Addendum to

Evaluating Water Storage Requirements for Akaroa Treated Wastewater Irrigation System Using Actual Flow Data from 2018-2023

29 November 2023

Dr. Brent Martin

Figure 1 Storage requirement in 2022 based on Inflow meter data compared with previous

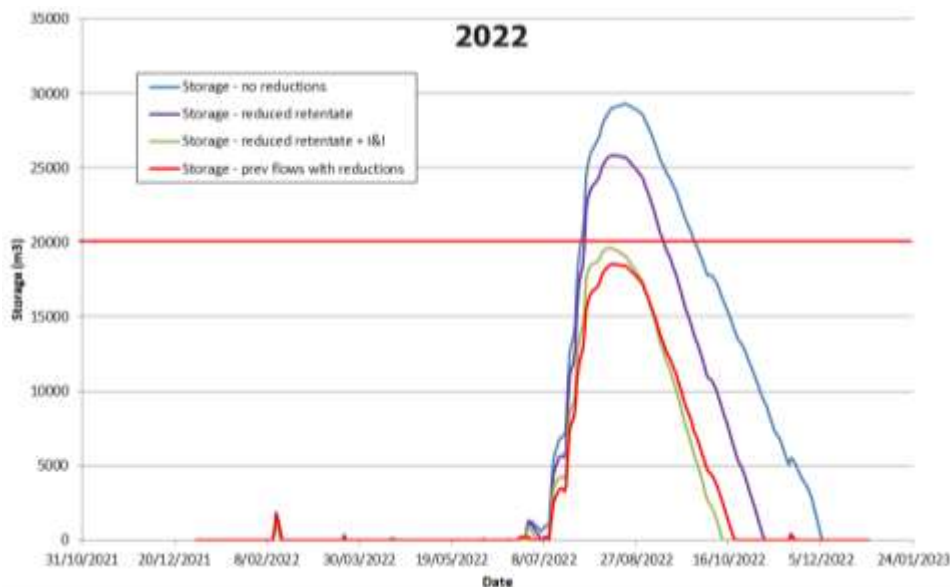
For 2022, the storage requirements based on the Inflow data increase slightly from those previously calculated using the Outflow data from 18,558m³ to 19,629m³. The chart below compares the old and new storage requirements.

As with the original analysis, the storage has been calculated using the raw data, the data adjusted down for the 75% drinking water retentate reduction that the system sizing is predicated on but the Council has yet to achieve and then for the 20% I&I reduction on which the system is also predicated. Although the Council completed I&I work in 2022, whether any substantive reduction in I&I has been achieved from these works is yet to be determined. The green line including both reductions is therefore the best possible case, it deducts the full 20% from the actual flow data. If the Council determines it has already achieved some or all of this 20% reduction through its work, then applying an additional 20% reduction to the data underestimates the flows.

Figure 2 Storage requirement in 2023 based on Inflow meter data compared with previous

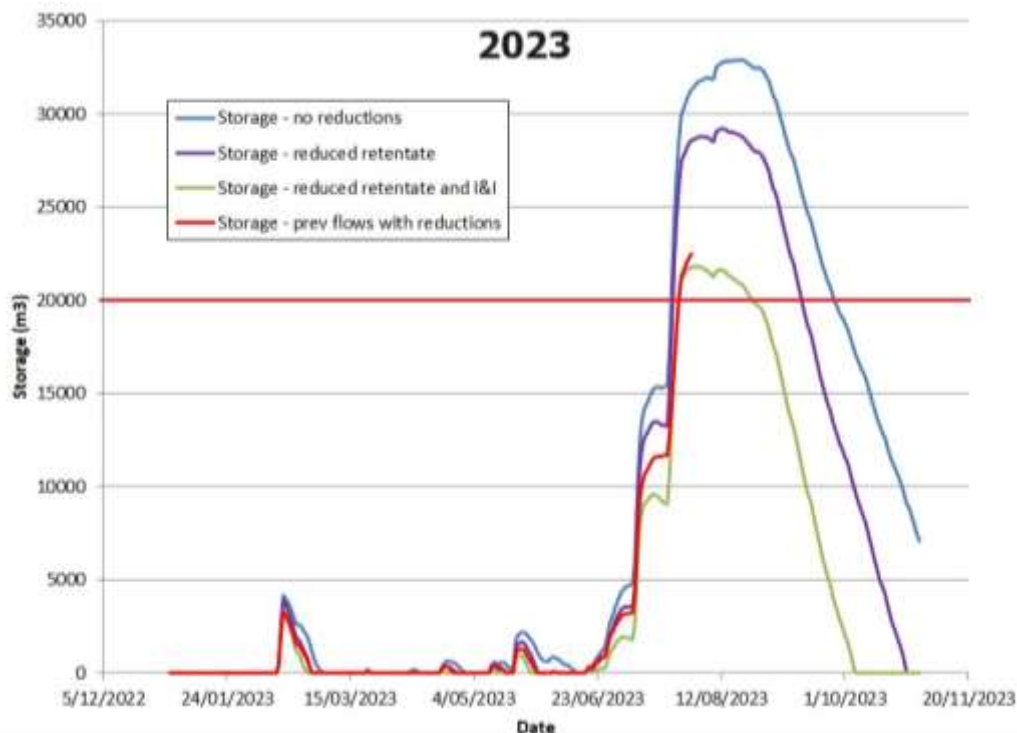
For 2023 using Inflow data with all the reductions applied decreases the storage requirement slightly from the 22,480m³ stated in the original evaluation to 21,803m³. This still exceeds the 20,000m³ maximum storage capacity applied for.

If a 20% reduction in I&I has in fact already been achieved and only retentate is further reduced, the storage requirement remains far above 20,000m³ at 29,210m³.

Again the chart below compares the storage requirements for the new Inflow data under the three scenarios (no reductions from current flows, retentate reduced by 75%, retentate reduced 75% and I&I further reduced by 20%) and compares it with the storage requirement in the previous analysis with all the reductions applied.

Figure 3 Inflow meter data versus faulty Outflow meter data for 2022

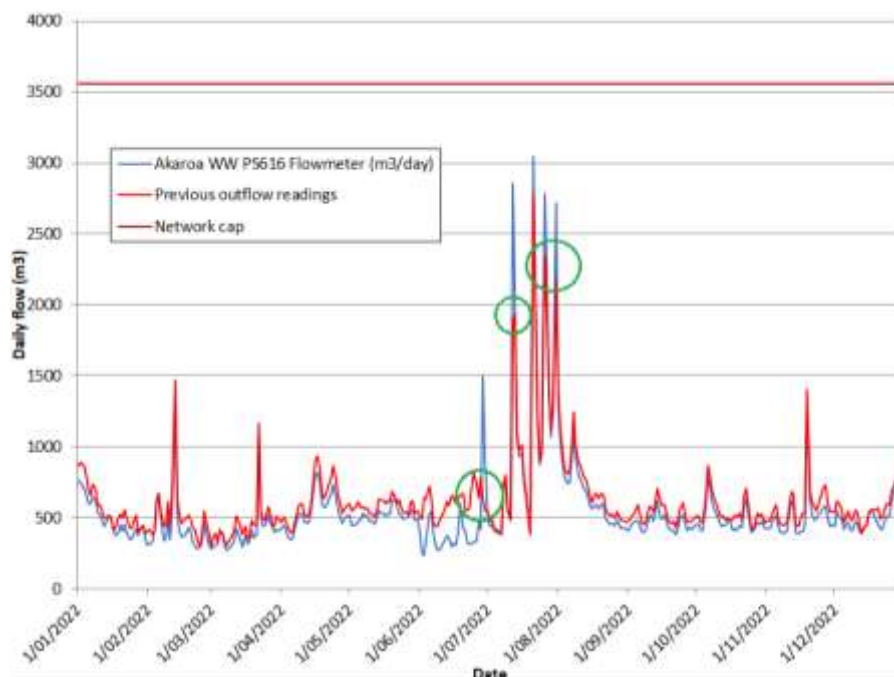
Comparison of Inflow meter data with the previous data used from the faulty Outflow meter shows significant differences in the flows, particularly during high rainfall events. On several occasions the peak inflows during rain spikes are much higher using the Inflow meter data than the faulty Outflow meter data, as indicated by the green circles on the graphs below.

Appendix U of the Application provides the PDP Irrigation Model and Water Balance Summary Letter. Under section 3.0, describing how the storage has been sized, PDP set out that when wastewater flow exceeds 3,562m³ per day it will overflow into the harbour prior to reaching the WWTP (Treatment Plant) and that this value corresponds to the volume from the network during a 24 hour, 1 in 10 year average recurrence interval storm. The red horizontal lines on the two previous Figures highlight this cap.

As can be seen, the flow data from the Outflow meter used in the original evaluation did not reach this cap. However, with the much higher peaks recorded by the Inflow data, this cap has now been breached. On 23rd July 4,019m³ was recorded by the Inflow meter as arriving at the current Akaroa wastewater treatment plant. It also came very close on 9th July when 3,554m³ was recorded.
